**ZONING AMENDMENT &  
SUBDIVISION STAFF REPORT****Date: March 5, 2015****APPLICANT NAME**

Kleban Shed, LLC

Shed Development Subdivision

**LOCATION**5753 Old Shell Road  
(Southeast corner of Old Shell Road and Long Street)**CITY COUNCIL  
DISTRICT**

# SITE PLAN

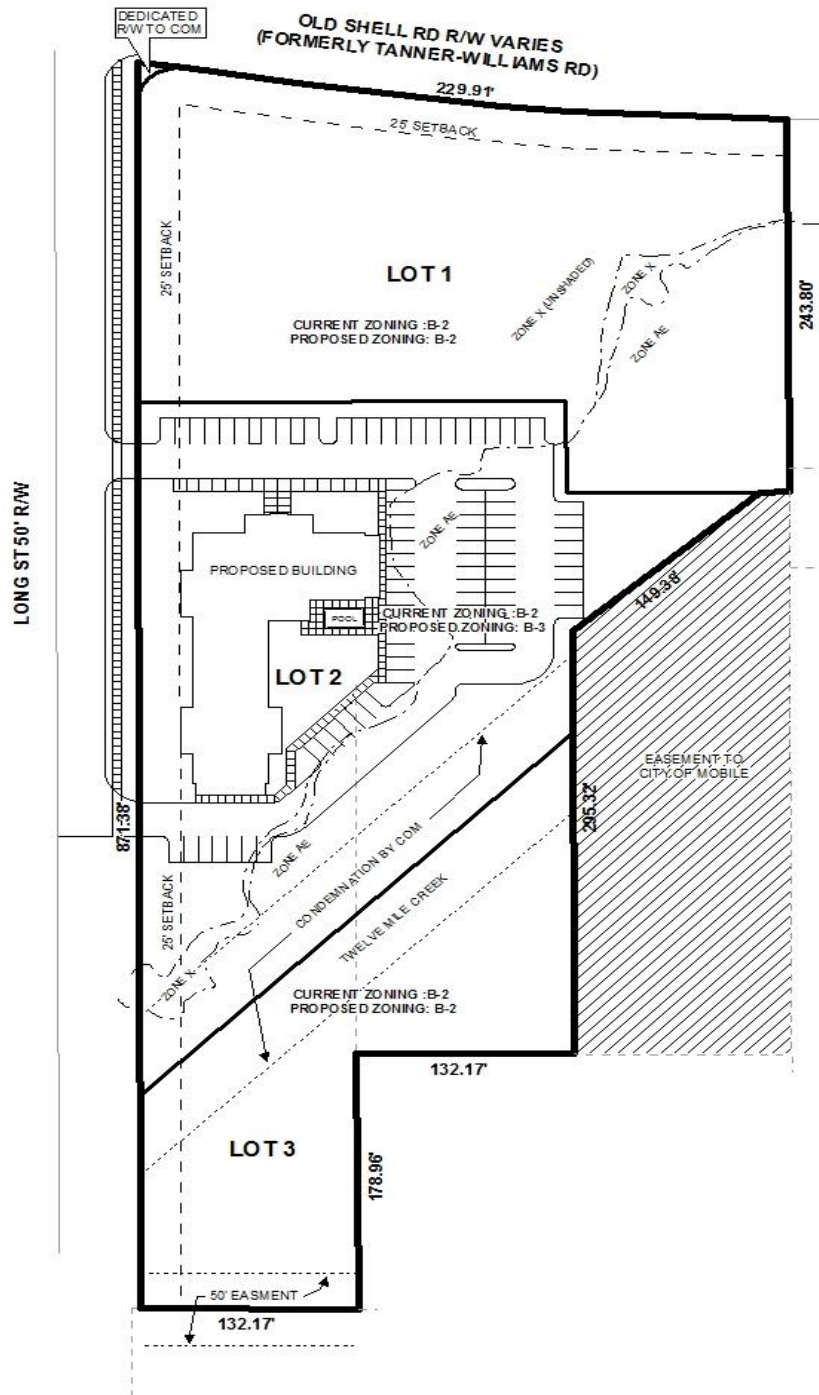
*In accordance with the Subdivision Regulations, all 3 proposed lots are compliant with the minimum size requirements. The 25' minimum building setback line and lot size information is illustrated on the preliminary plat and should be retained on the Final Plat, if approved.*

*The site fronts Old Shell Road and Long Street. Old Shell Road is a major street, as depicted in the Major Street Plan component of the Comprehensive Plan, with a compliant right-of-way width; however, the minimum right-of-way width adjacent to the site should be depicted on the Final Plat, if approved. Long Street is a substandard minor street in terms of width and level of improvement and should be improved along the entire property frontage on the North side of 12 Mile Creek in conjunction with any associated commercial development of Lots 1-3. The provision of a corner radius in compliance with Section V.D.6. of the Subdivision Regulations should be required at the southeast corner of Long Street and Old Shell Road. The lot size information and 25' minimum building setback line should be revised to reflect dedication.*

*It should be pointed out that large power lines are present along Long Street which may mean there is an easement not shown on the preliminary plat. As such, if necessary, the Final Plat should be revised to illustrate all easements along with a note stating no permanent structure can be placed or erected within any easement, if approved.*

- 1) Provision of a corner radius at the southeast corner of Old Shell Road and Long Street, in compliance with Section V. D.6. of the Subdivision Regulations;*

- 2) Dedication along Long Street, sufficient to provide 25' as measured from centerline, if necessary;*
- 3) Revision of the lot size information and 25' minimum building setback line on the Final Plat to reflect any dedication;*

- 4) Illustration of all easements on the Final Plat, along with a note stating no permanent structure can be placed or erected within any easement;*
- 5) Placement of a note on the Final Plat stating that Long Street should be improved to City of Mobile standards at the time of development of each lot;*

- 6) Placement of a note on the Final Plat stating that site is limited to two curb cuts to Old Shell Road, and five curb cuts to Long Street, with the size, design and location to be approved by Traffic Engineering and conform to AASHTO standards, with all unused curb-cuts removed and replaced with landscaped material;*
